## Appendix C: Facility Reports for City Buildings and Parks

Civic Center Path of Travel and Parking

Bocce: 4-1, 33-1

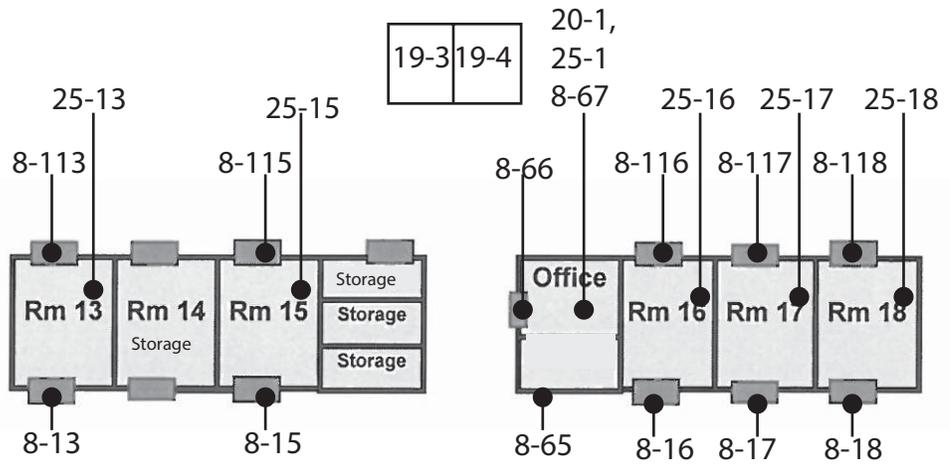
<b>Replace or reposition drinking fountain</b>		\$5,000
Notes: Fountain depth is 14" (18-19" req.)		
State: 1117B.1.2		
Federal: -		
<b>32 - 1</b>	<b>Picnic Area</b>	Priority: 3
<b>Provide an accessible table</b>		\$2,500
Notes: Courtyard: Knee space is not provided at the game tables.		
State: -		
Federal: AGODA 1011.4

<b>Exterior</b>		
<b>32 - 2</b>	<b>Picnic Area</b>	Priority: 3
<b>Provide an accessible table</b>		\$2,500
Notes: Courtyard: Knee space is not provided at the game tables.		
State: -		
Federal: AGODA 1011.4		
<b>33 - 1</b>	<b>Outdoor Constructed Features</b>	Priority: 3
<b>Provide an accessible path of travel</b>		\$5,000
Notes: Three benches are provided in the bocce ball area. There is no accessible path of travel or companion seating provided.		
State: -		
Federal: 206.2, AGODA 1011.2.1		
<b>33 - 2</b>	<b>Outdoor Constructed Features</b>	Priority: 3
<b>Regrade surface</b>		\$1,000
Notes: Courtyard: Level space near bench is 3.5% (2% max.)		
State: -		
Federal: AGODA 1011.2.3

3-1

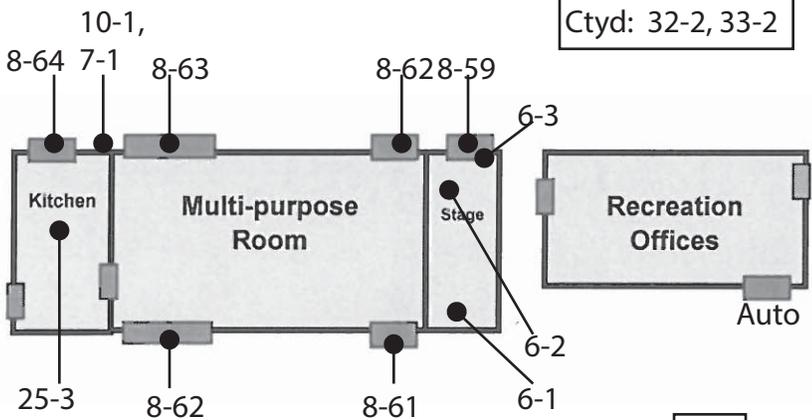
<b>Exterior</b>		
<b>3 - 1</b>	<b>Curb Ramp</b>	Priority: 1
<b>Provide detectable warning strip</b>		\$1,000
Notes: Truncated domes are not provided on the curb ramp.		
State: 1127B.5.7		
Federal: -		
<b>Install, replace or modify curb ramp</b>		\$3,500
Notes: Slope of flared sides exceed 10%.		
State: 1127B.5.3, 1127B.5.4		
Federal: 406.3		
<b>4 - 1</b>	<b>Walk</b>	Priority: 3
<b>Regrade surface</b>		\$500
Notes: Slope to bocce ball area is 7.1%. 5ft.		
State: 1133B.7.3		
Federal: 403.3		
<b>7 - 1</b>	<b>Hazard</b>	Priority: 1
<b>Remove overhanging or protruding objects</b>		\$1,000
Notes: Drinking fountain is located in the path of travel and protrudes 14" (4" max.) and is located 25" AFF (below 27", above 80" req.)		
State: 1133B.8.6		
Federal: 307.2		
<b>10 - 1</b>	<b>Drinking Fountain</b>	Priority: 3
<b>Adjust water stream</b>		\$100
Notes: Controls require grasping and twisting.		
State: 1117B.6.4		
Federal: 309
